**CONTRACT
CHANGE
ORDER**

CCO No.: 002

PROJECT	PROGRAM NO.	CONTRACT NO.	SUPPL NO.	CHANGE REQUESTED BY:
Alder/Randall Street Improvement Project		P-140809		<input type="checkbox"/> OWNER <input type="checkbox"/> CONTRACTOR
TO: Rick Garabedian, JM Olvera TITLE: Storm Drain Laterals 3, 4, and 6 Revisions				OTHER ID LPPSB1L-5205(028)

(RFP-003) Storm Drain Laterals 3, 4, and 6 Revisions:

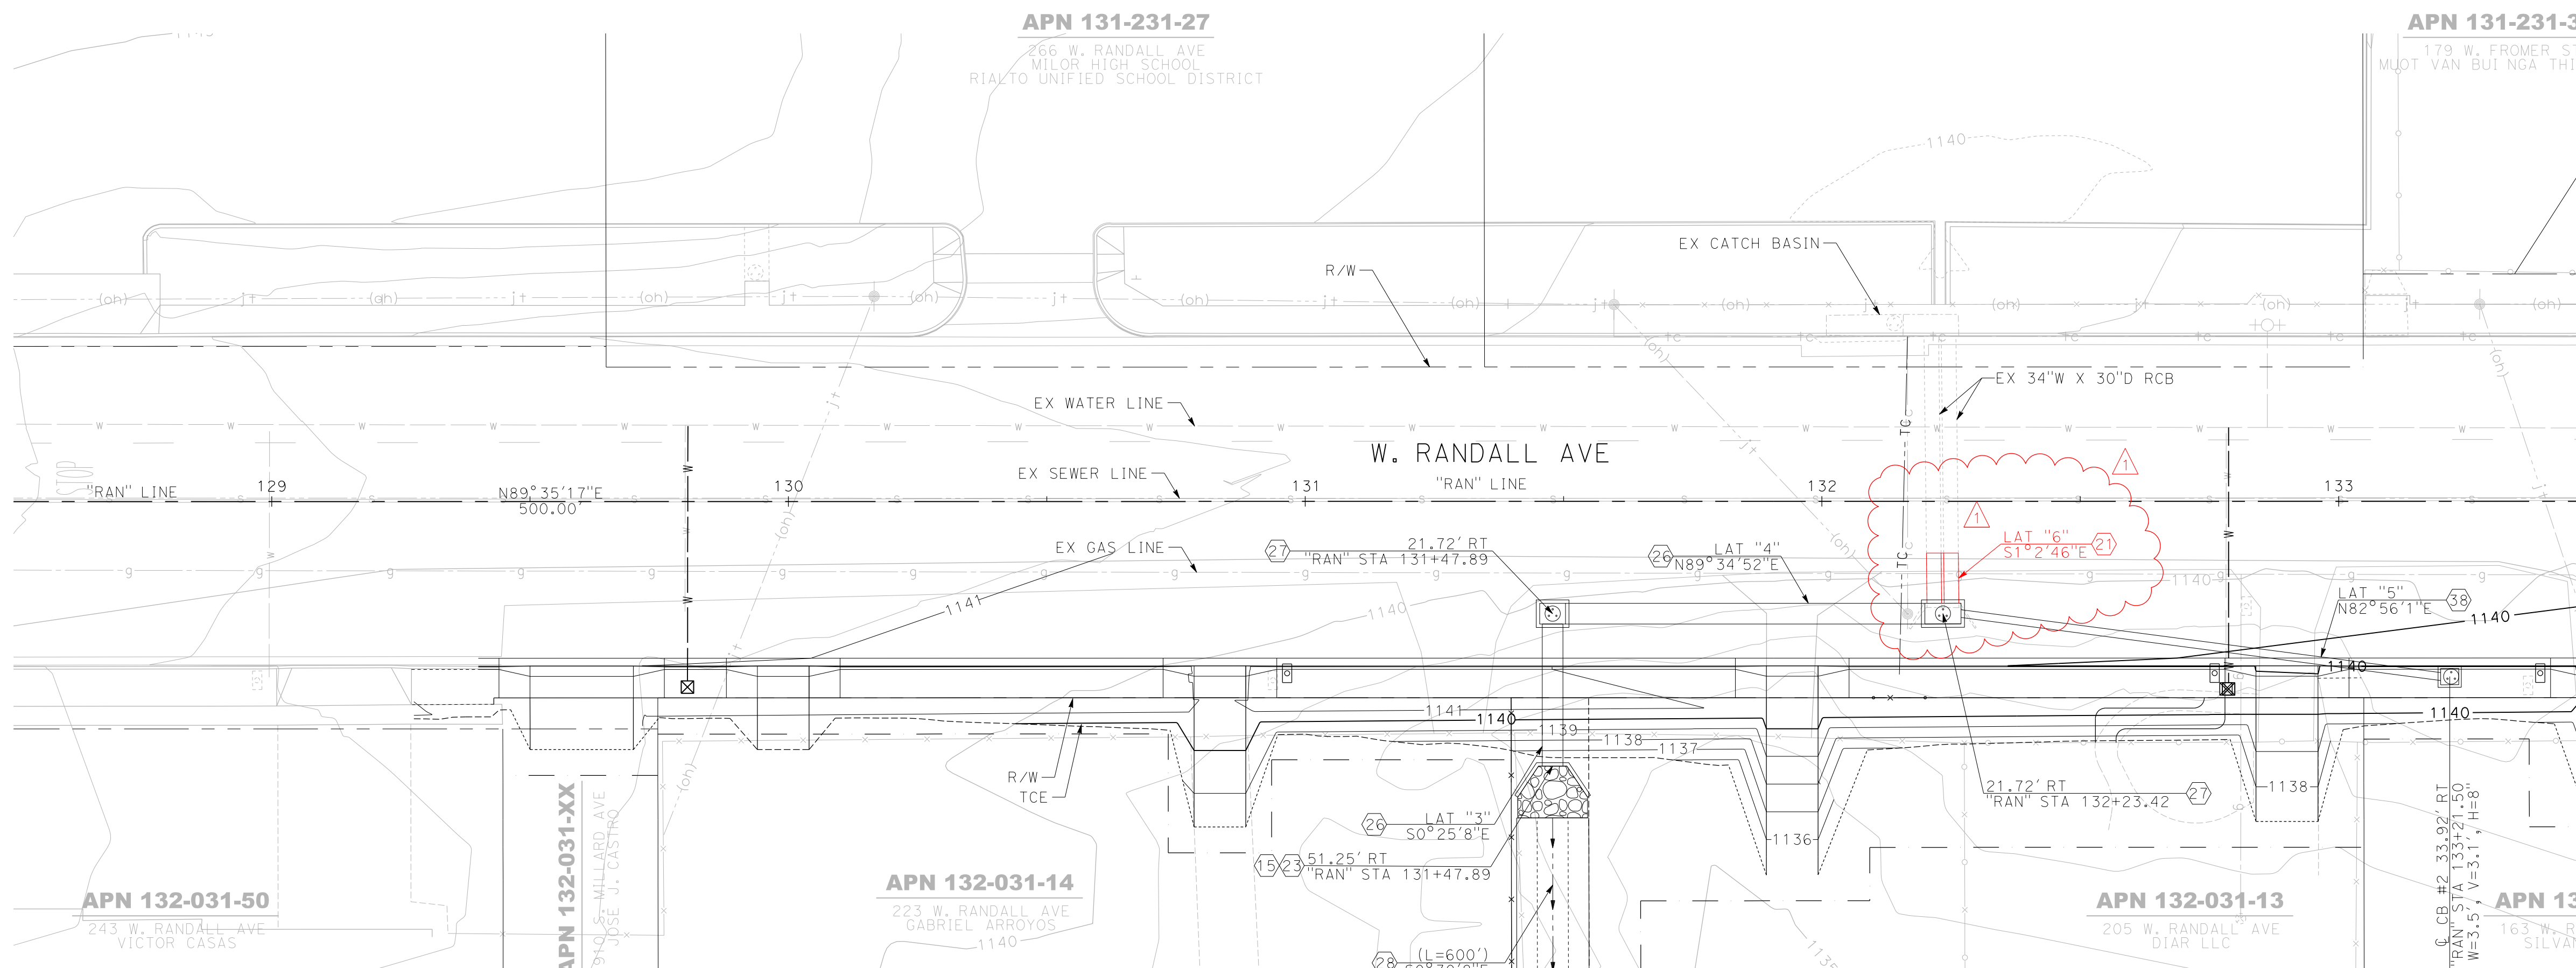
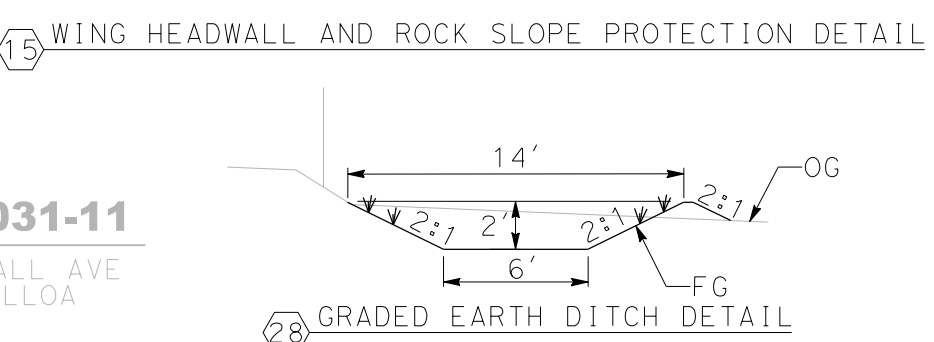
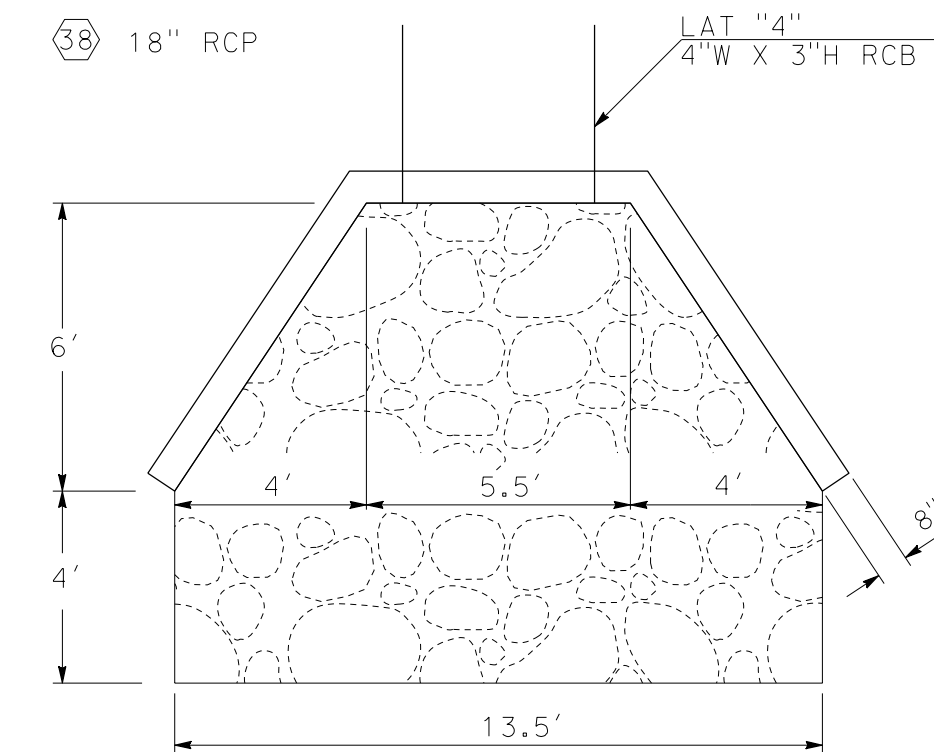
Construct Storm Drain Laterals 3, 4, 5, and new Lateral 6 and associated Junction Structures per the attached modified Drainage Plans – Sheets 44, 44A, 44B, and 44C of 105. Demolish and remove approximately 10 feet of double Reinforced Concrete Box per the attached Demolition Plan Sheet 10 of 105.

- 1) Remove a segment of the existing double RCB box at Station 132+23.32 from 10 ft right to the existing headwall as shown on Sheet 10 of 105 Rev. 01.
- 2) Construct the new Lateral 6, cast in place double RCB box at Sta. 132+23.32, from 10 ft. right to approx. 19.7 ft. right as shown on Sheet 44A of 105.
- 3) Construct Laterals 3 and 4 to revised grades as shown on Sheet 44 of 105 Rev. 01.
- 4) Construct Junction Structure “RAN” 132+23.42 per details shown on Sheet 44B of 105 (Modified from SPPWC Standard Plan 320-2).
- 5) Construct Junction Structure “RAN” 131+47.89 per details shown on Sheet 44C of 105 (Modified from SPPWC Standard Plan 320-2).
